## UNITED STATES PATENT AND TRADEMARK OFFICE

APPLICATION NO.	FILING DATE	FIRST NAMED INVENTOR	ATTORNEY DOCKET NO.	CONFIRMATION NO.
10/774,399 02/10/2004		Benjamin Amette Lagrange	839-1433 9855	
	7590 NDERHYE P.C. FLEBE ROAD, 11TH FLOOR	EXAMINER  VERDIER, CHRISTOPHER M		
ARLINGTON,		-	ART UNIT	PAPER NUMBER
			3745	
		•	MAIL DATE ·	DELIVERY MODE
•	•		05/14/2007	DADED

Application No.	Applicant(s)			
Office Action Summan	10/774,399	LAGRANGE ET AL.			
Office Action Summary	Examiner	Art Unit			
T. MAII 110 DATE 121	Christopher Verdier	3745			
The MAILING DATE of this communication appeariod for Reply	ppears on the cover sheet with the	corresponaence address			
A SHORTENED STATUTORY PERIOD FOR REP WHICHEVER IS LONGER, FROM THE MAILING I - Extensions of time may be available under the provisions of 37 CFR 1 after SIX (6) MONTHS from the mailing date of this communication.  - If NO period for reply is specified above, the maximum statutory processed in the period for reply within the set or extended period for reply will, by statu. Any reply received by the Office later than three months after the mail earned patent term adjustment. See 37 CFR 1.704(b).	DATE OF THIS COMMUNICATIO 1.136(a).

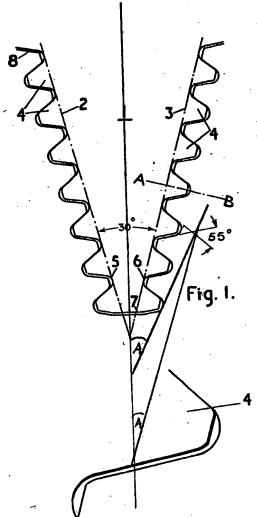
U.S.C. 102(b) as being anticipated by United Kingdom Patent 677,142. Note the unnumbered bucket for insertion into an unnumbered wheelpost of an unnumbered turbine rotor in a third stage of a turbine, the bucket being formed from interleaved unnumbered fillets and tangs 4 which complement interleaved fillets and tangs formed in the wheelpost, with the two uppermost tangs on either side of a center line bisecting each of the buckets each respectively defining a point of a line that forms an angle of 25.78 degrees, with each of the points being determined by intersecting tangent lines along pressure faces of the respective uppermost tangs, and a point define by intersecting tangent lines along pressure faces of the bottommost tang does not lie on either line that forms the angle of 25.78 degrees. The bucket has three interleaved tangs and fillets. Note that these claims still do not specifically recite the particular geometry of the

intersection of the angle formed by tangent lines along uppermost tangs on either side of the center line bisecting each of the buckets. That is, a line drawn from the intersection of the angle formed by tangent lines to pressure faces of the two uppermost tangs (shown in figure 1 of United Kingdom Patent 677,142 at the intersection near the marked 55 degree angle as an example) on each side of a center line bisecting each of the buckets may be selectively drawn such that it intersects the center line (at a portion of the center line remote from the blade root) and forms the aforementioned 25.78 degree angle, with the lines defined by the uppermost tangs not coinciding with a point formed by the bottommost tang, such that this angle is the same as Applicant's angle E of 25.78 degrees in figure 10, since the location where the drawn line that forms the angle E intersects the center line is an arbitrary location. See the annotated figure below.

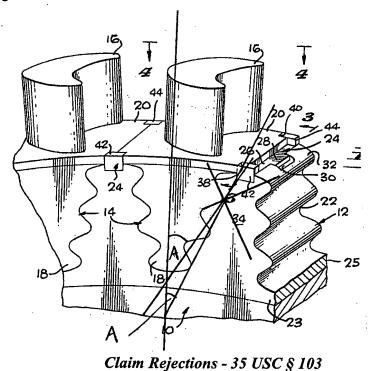
Claims 29-32 and 34-36, as far as they are definite and understood, are rejected under 35 U.S.C. 102(b) as being anticipated by Webb 3,202,398. Webb discloses a bucket 16 for insertion into a wheelpost 34 of a turbine rotor 10 in a third stage of a turbine, the bucket being formed from interleaved unnumbered fillets and tangs which complement interleaved fillets and tangs (near 22) formed in the wheelpost. The bucket has three interleaved tangs and fillets. The bucket has a bottom tang 18 formed from curved surfaces having more than one radius of curvature. The bucket further includes at least one straight surface (the leading and trailing edges). The bucket has an upper tang formed from curved surfaces having more than one radius of curvature. The two uppermost tangs on either side of a center line bisecting each of the buckets each respectively define a point of a line that forms an angle of 25.78 degrees, with each of the points being determined by intersecting tangent lines along pressure faces of the respective uppermost tangs, and a point defined by intersecting tangent lines along pressure faces of the bottommost tang does not lie on either line that forms the angle of 25.78 degrees. Note that these claims still do not specifically recite the particular geometry of the intersection of the angle formed by tangent lines along uppermost tangs on either side of the center line bisecting each of the buckets. That is, a line drawn from the intersection of the angle formed by tangent lines to pressure faces of the two uppermost tangs on each side of a center line bisecting each of the buckets may be selectively drawn such that it intersects the center line (at a portion of the center line remote from the blade root) and forms the aforementioned 25.78 degree angle, with the lines defined by the uppermost tangs not coinciding with a point formed by the bottommost tang, such that this angle is the same as Applicant's angle E of 25.78 degrees in figure 10, since the location

where the drawn line that forms the angle E intersects the center line is an arbitrary location. See the annotated figure below.

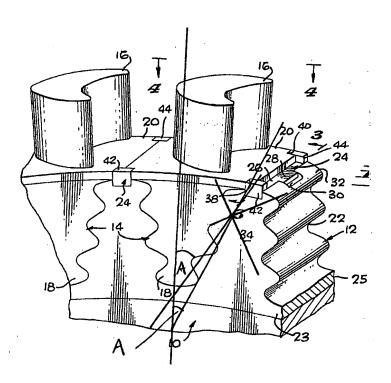
Claims 10-11, 13-17 and 21-25, as far as they are definite and understood, are rejected under 35 U.S.C. 103(a) as being unpatentable over Webb 3,202,398 in view of Applicant's Prior Art. Webb discloses a turbine substantially as claimed, comprising a wheel 10 having plural broach slots 22, each having an interleaved system of fillets and tangs, and plural buckets 16 each having a corresponding interleaved system of fillets and tangs so that the plural buckets can be filled, one to one, into the plural broach slots, with the interleaved system of fillets and tangs on the buckets and wheelposts 34 inherently acting to reduce stresses acting on the fitted buckets and wheelposts (due to the dovetail shape), the fillets and tangs of the interleaved system of fillets and tangs each being formed by a combination of curved and straight surfaces. The buckets and wheelposts have three interleaved tangs and fillets. Each of the buckets has a bottommost tang 18 formed from unnumbered curved surfaces having more than one radius of curvature (at the bottom of the tang and the top of the tang). Each bucket has straight surfaces (the leading and trailing edges). Each of the wheelposts has an unnumbered bottom fillet formed from curved surfaces having more than one radius of curvature (at the bottom and at the top). Each wheelpost includes unnumbered straight surfaces. The two uppermost tangs on either side of a center line bisecting each of the buckets each respectively define a point of a line that forms an angle of 25.78 degrees, with each of the points being determined by intersecting tangent lines along pressure faces of the respective uppermost tangs, and a point define by intersecting tangent lines along pressure faces of the bottommost tang does not lie on either line that forms the angle of 25.78 degrees. The two uppermost fillets on either side of a center line bisecting each of the buckets each respectively define a point of a line that forms an angle of 25.78 degrees, with each

of the points being determined by intersecting tangent lines along pressure faces of the respective uppermost fillets, and a point defined by intersecting tangent lines along pressure faces of the bottommost fillet does not lie on either line that forms the angle of 25.78 degrees. Note that these claims still do not specifically recite the particular geometry of the intersection of the angle formed by tangent lines along uppermost tangs and fillets on either side of the center line bisecting each of the buckets. That is, a line drawn from the intersection of the angle formed by tangent lines to pressure faces of the two uppermost tangs or fillets on each side of a center line bisecting each of the buckets may be selectively drawn such that it intersects the center line (at a portion of the center line remote from the blade root) and forms the aforementioned 25.78 degree angle, with the lines defined by the uppermost tangs or fillets not coinciding with a point formed by the bottommost tang or fillet, such that this angle is the same as Applicant's angle E of 25.78 degrees in figure 10, since the location where the drawn line that forms the angle E intersects the center line is an arbitrary location. See the annotated figure below.
